ADDENDUM NUMBER THREE

DARLA MOORE SCHOOL OF BUSINESS CONSTRUCTION – BP-2 STRUCTURE
UNIVERSITY OF SOUTH CAROLINA
STATE PROJECT NUMBER H27-6069-AC-2

DATE OF ISSUE: January 20, 2012

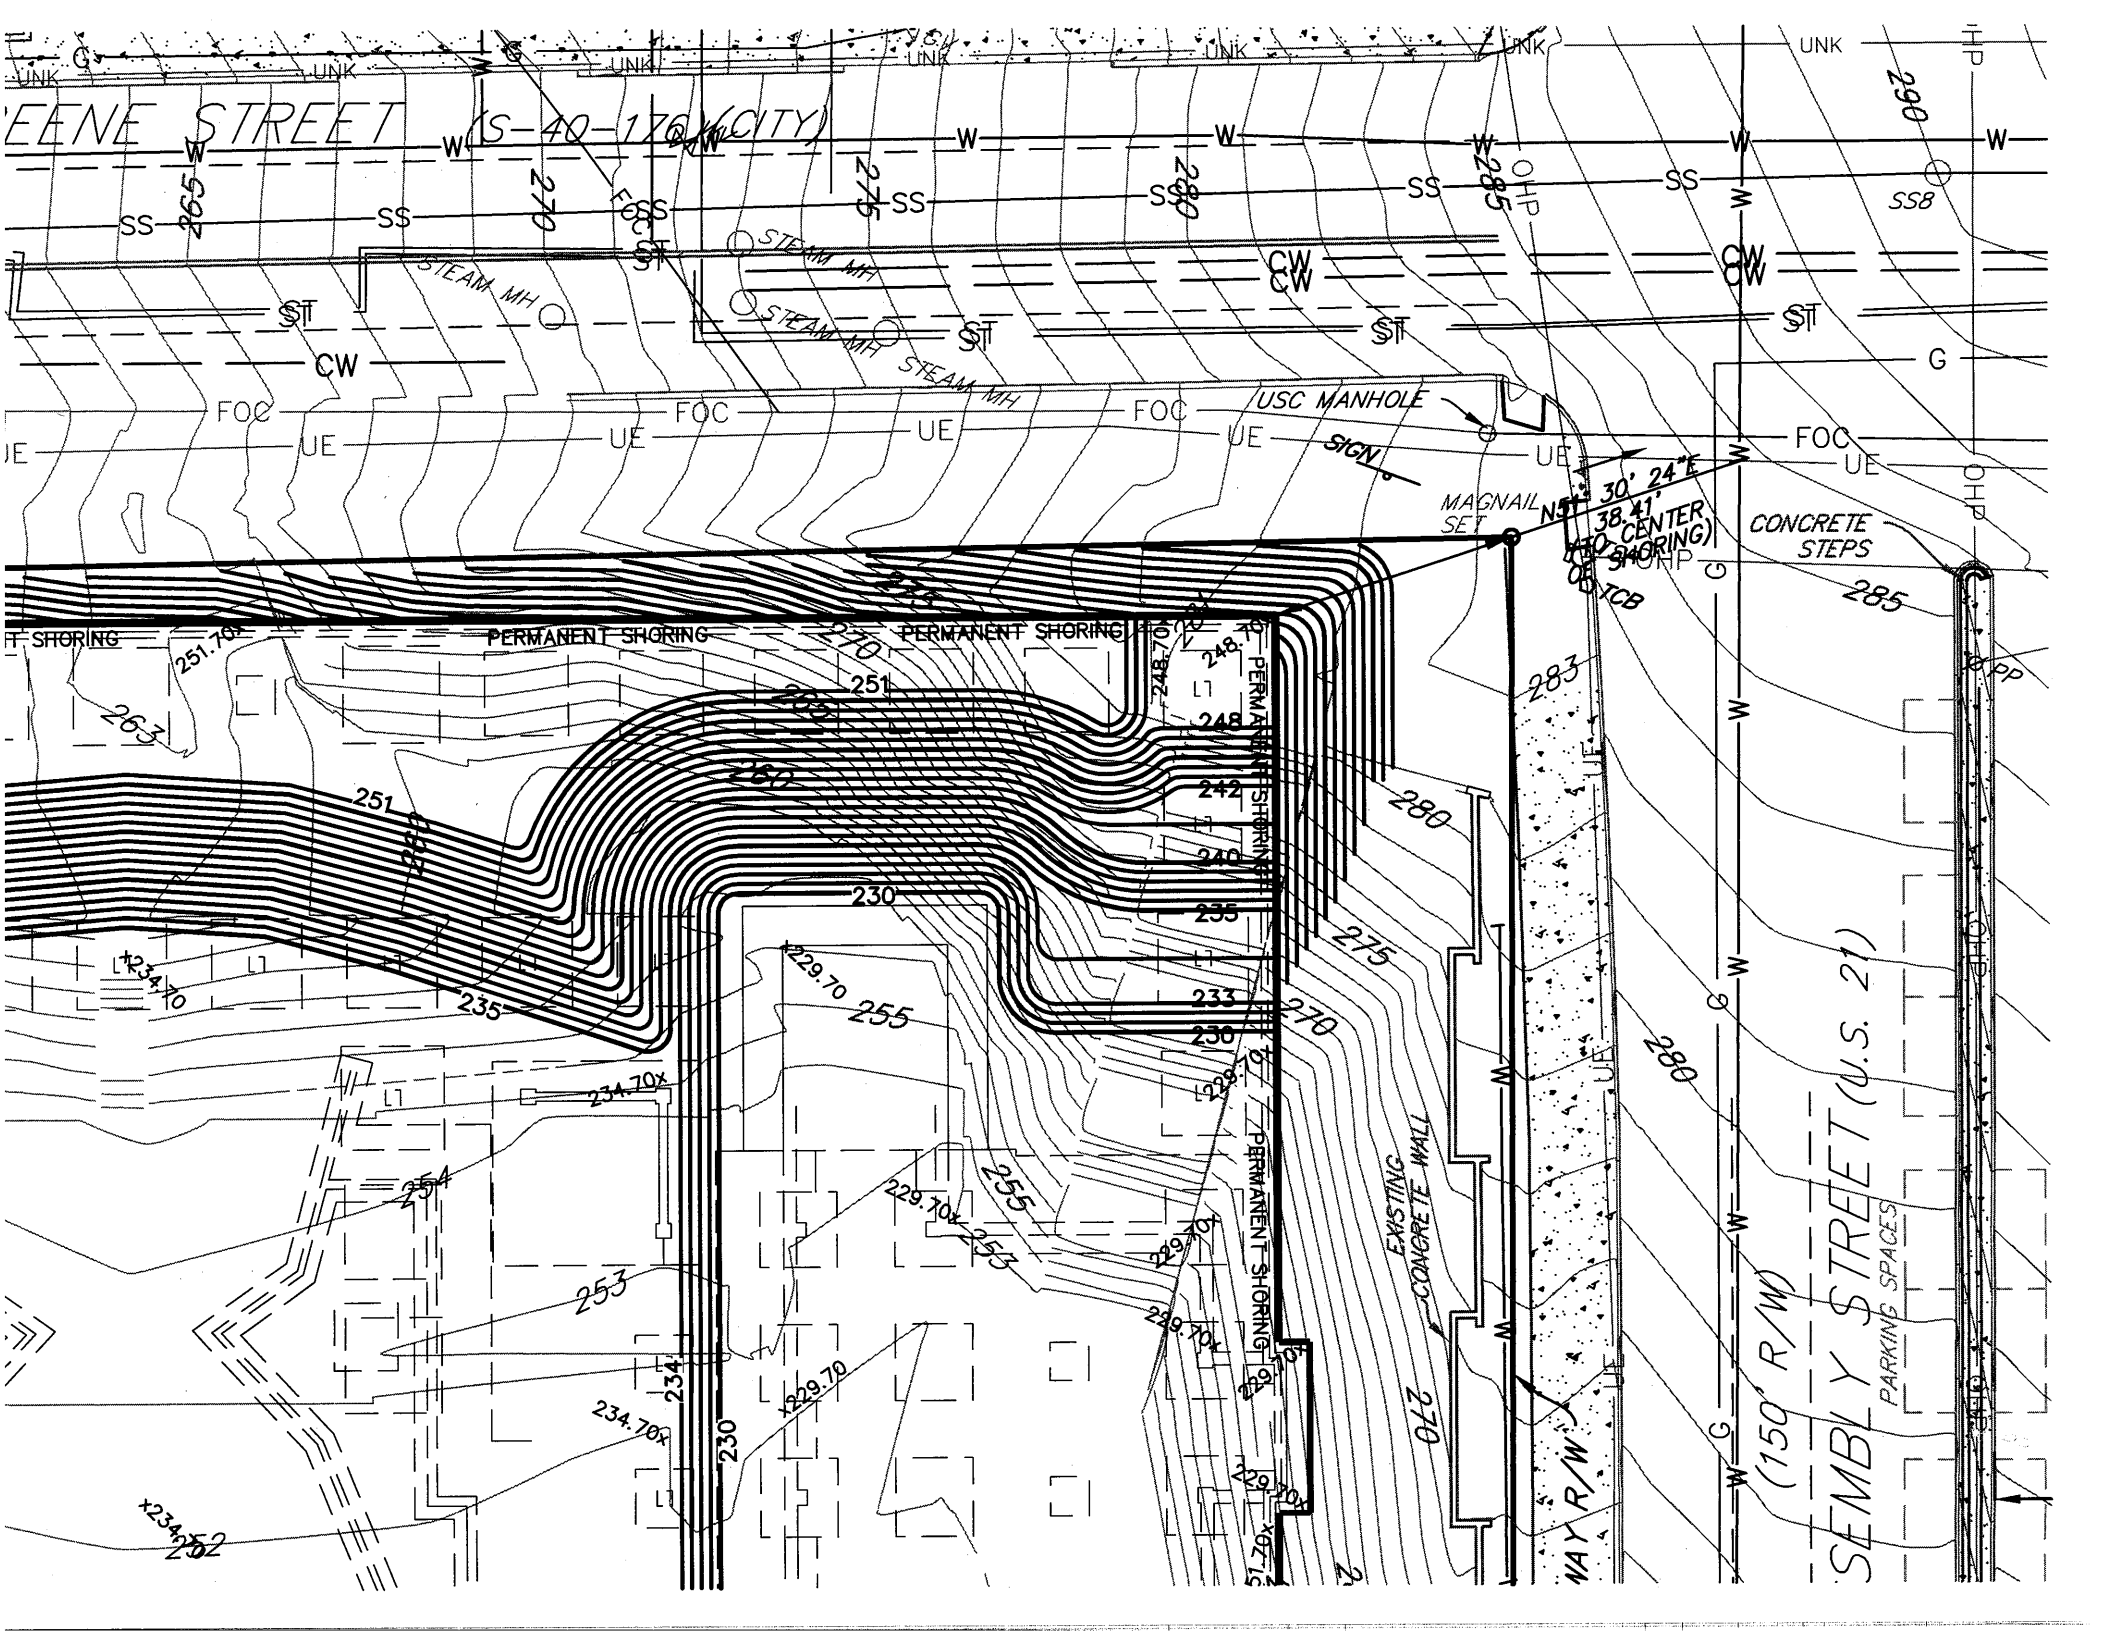
1. Plan Sheet C1300: Refer to Partial Revised Grading Plan attached. Grades to be established in the work of the Bid Package 1C Civil contract have been adjusted as shown and the depth of the earth retention shoring wall has been extended. Adjust foundation excavation and backfill requirements accordingly.
